Amersham Corporation
40 North Avenue
Burlington, MA 01803
tel (617) 272-2000
tel (800) 225-1383

31 March 1994

In reference to docket number 71-9033, we are providing the additional information requested in your letter dated 15 December 1993.

Amersham Corporation, Model 660 series is designed for use as a radiographic exposure device and a transport package for Type B quantities of radioactive material in special form. The Model 660 conforms to the criteria for Type B(U) packaging in accordance with 10 CFR 71 and IAEA Safety Series No. 6, 1985 Edition (as amended).

MODEL 660 GAMMA RAY PROJECTOR SHIPPING CONTAINER DESCRIPTIVE ASSEMBLY
AS NOTED	CLASSIFICATION: C	PART NO: 66025
DRAWN BY: [Signature]	CHECKED BY: [Signature]	SCALE: 1/1
APPROVED BY: [Signature]	DATE:	SHEET: 3 OF 3

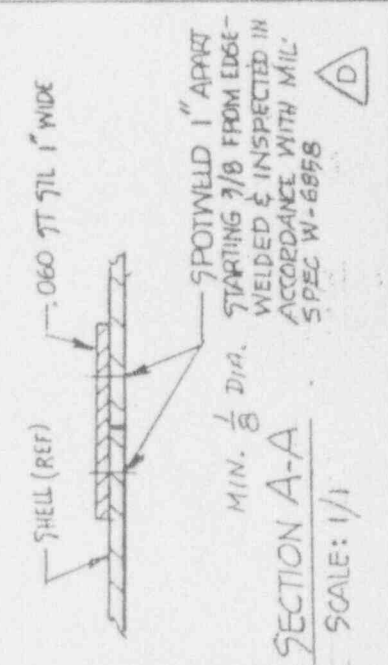
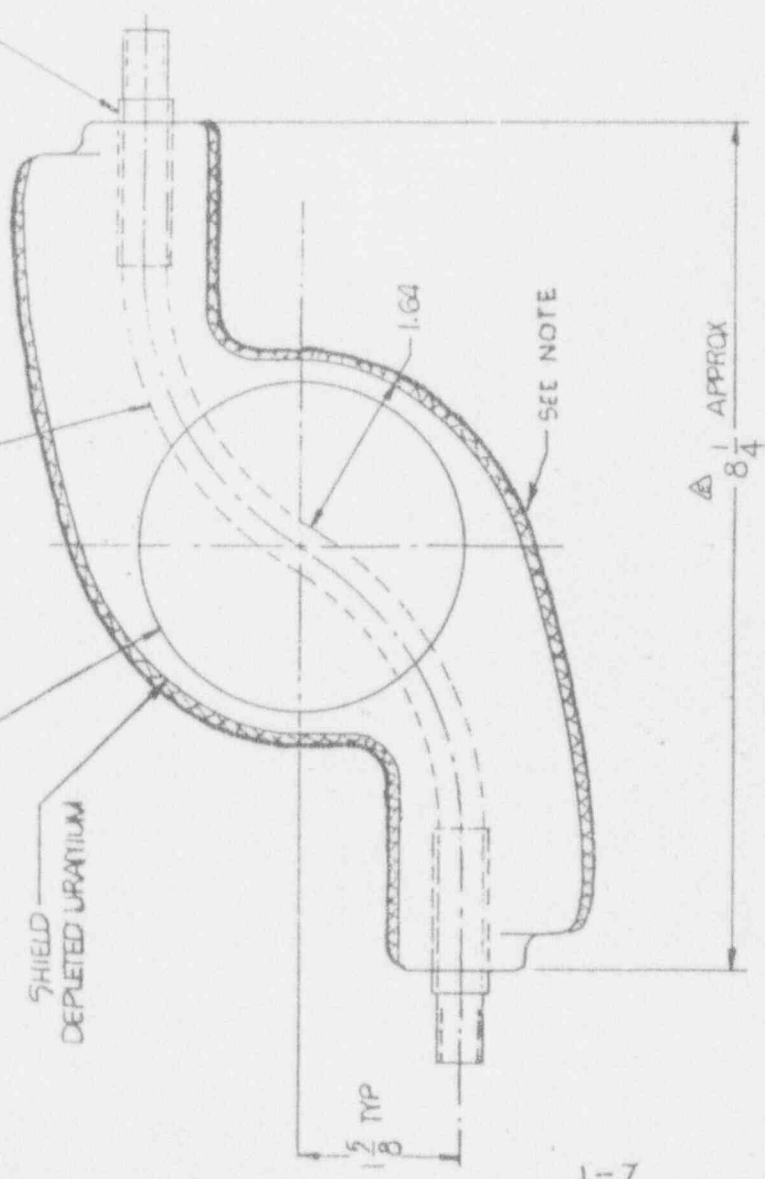
- 1) Drawing 66030 sheets 1-4 were inadvertently left out of our consolidated application. We have enclosed these drawings.
- 2) The changes made to these drawings were inadvertent and they have been revised to reflect the proper information and revision level.
- 3) The drawings have been revised to show the additional lead shielding on the shield and the text changed on page 2-1.

NOTE: ADDITIONAL LEAD SHIELDING NOT TO EXCEED 3 lbs. MAX. THICKNESS 1/4". TUNGSTEN NOT SHOWN.

MATERIALS		Radiation Products Division BURLINGTON, MA 01803	
AS NOTED		ONE TITLE	
MODEL 660 GAMMA RAY PROJECTOR SHIPPING CONTAINER		CLASSIFICATION	
DESIGNER		C	
DRAWN		-66030	
CHECKED		SCALE 1/1	
APPROVED		PAGE 3 OF 3

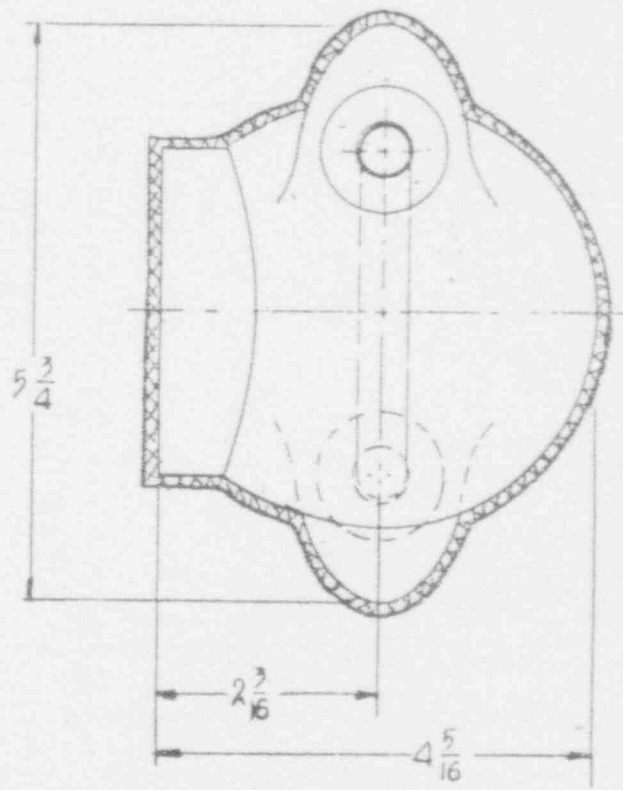
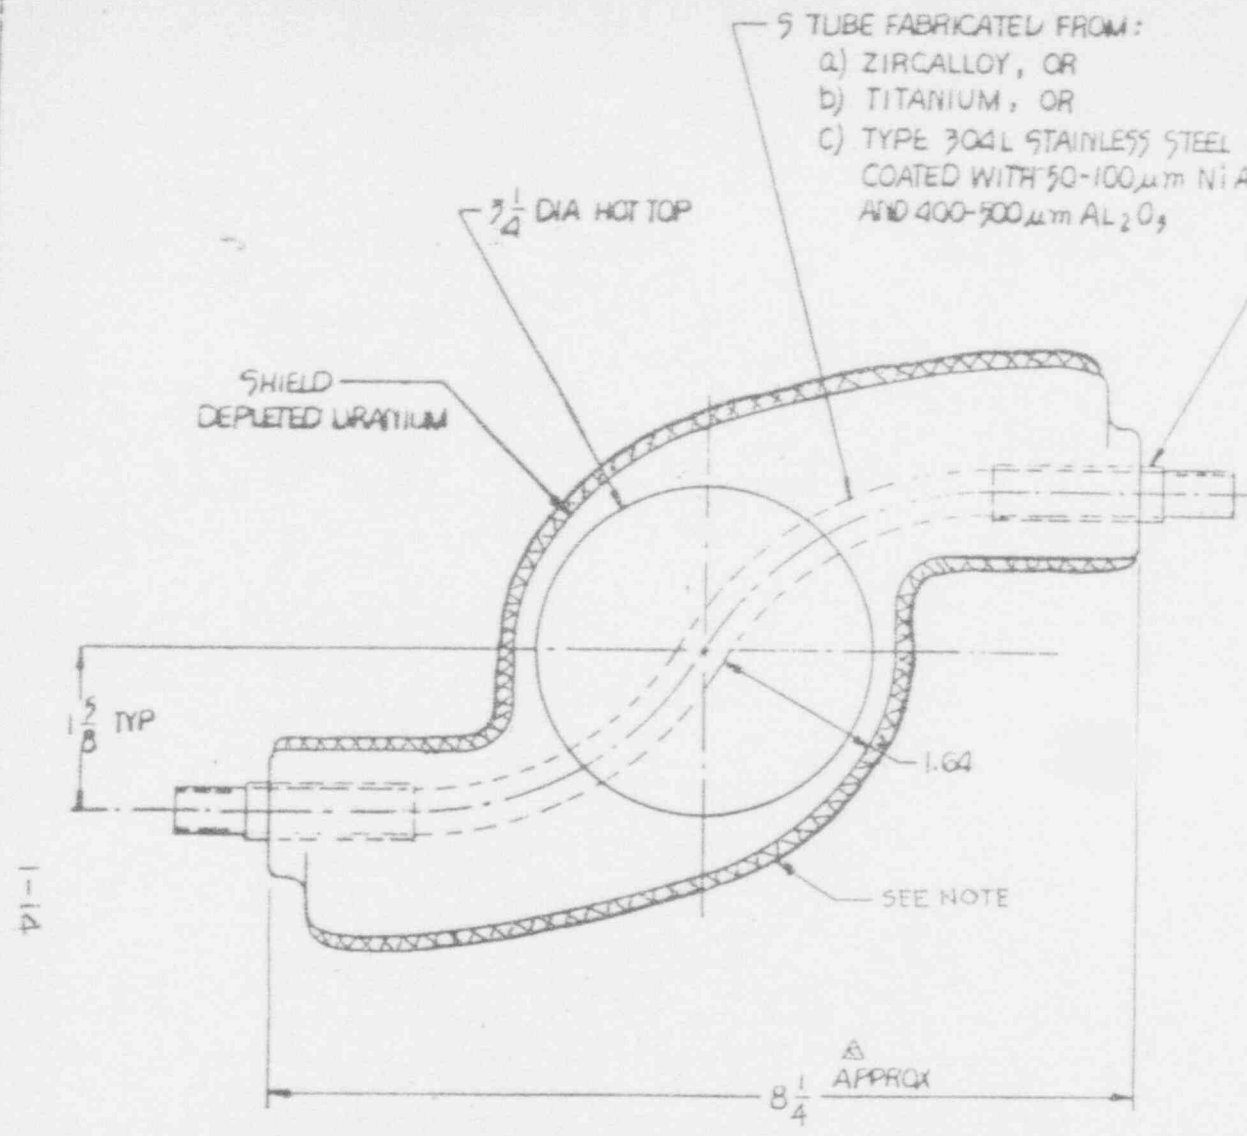
NOTE: ADDITIONAL LEAD SHIELDING NOT TO EXCEED 3lbs. MAX. THICKNESS 1/4". TUNGSTEN NOT SHOWN.
